RESPONSE TO REQUEST FOR ADDITIONAL INFORMATION

APR1400 Design Certification

Docket No. 52-046

RAI No.: 138-8067
SRP Section: 16 - Technical Specifications
Application Section: 16.3.0 LCO and SR Applicability
Date of RAI Issued: 08/07/2015

Figure B 3.0-1
 Configuration of Trains and Systems

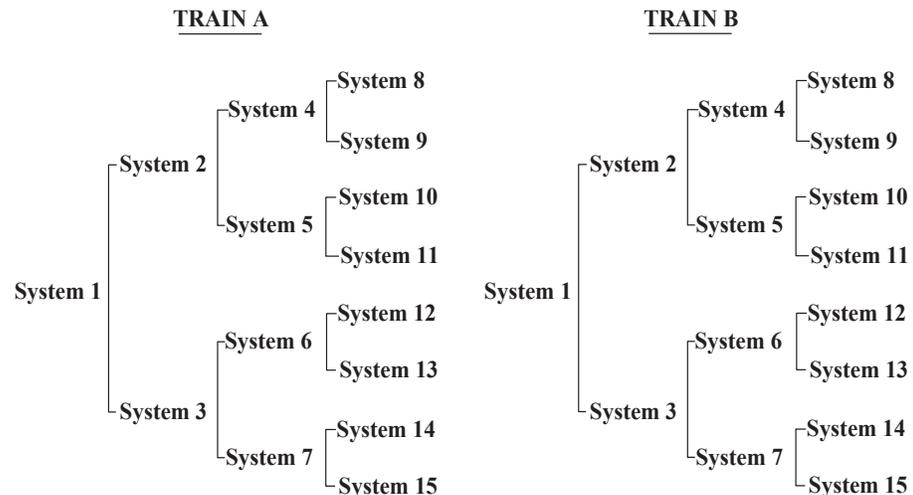
After the fourth paragraph in the LCO 3.0.6 Bases there are numerous wording changes from the STS LCO 3.0.6 Bases, including the entire last paragraph of the STS LCO 3.0.6 Bases being left out in the generic TS LCO 3.0.6 Bases. The Deviation Report, "APR1400-K-O-NR-14001-NP," does not address these differences. Justify the differences or make corrections.

The following examples use Figure B 3.0-1 to illustrate loss of safety function conditions that may result when a TS support system is inoperable. In this figure, the fifteen systems that comprise Train A are independent and redundant to the fifteen systems that comprise Train B. To correctly use the figure to illustrate the SFDP provisions for a cross train check, the figure establishes a relationship between support and supported systems as follows: the figure shows System 1 as a support system for System 2 and System 3; System 2 as a support system for System 4 and System 5; and System 4 as a support system for System 8 and System 9. Specifically, a

The LCO 3.0.6 Bases will be modified to be consistent with the content and wording of STS B 3.0.6.

For the following examples, see Figure B3.0-1.

EXAMPLE B 3.0.6-1

If System 2 of Train A is inoperable, and System 5 of Train B is inoperable, a loss of safety function exists in ~~supported System 5.~~

Systems 5, 10 and 11.

EXAMPLE B 3.0.6-2

If System 2 of Train A is inoperable, and System 11 of Train B is inoperable, a loss of safety function exists in System 11 ~~which is in turn supported by System 5~~

EXAMPLE B 3.0.6-3

If System 2 of Train A is inoperable, and System 1 of Train B is inoperable, a loss of safety function exists in Systems 2, 4, 5, 8, 9, 10, and 11.
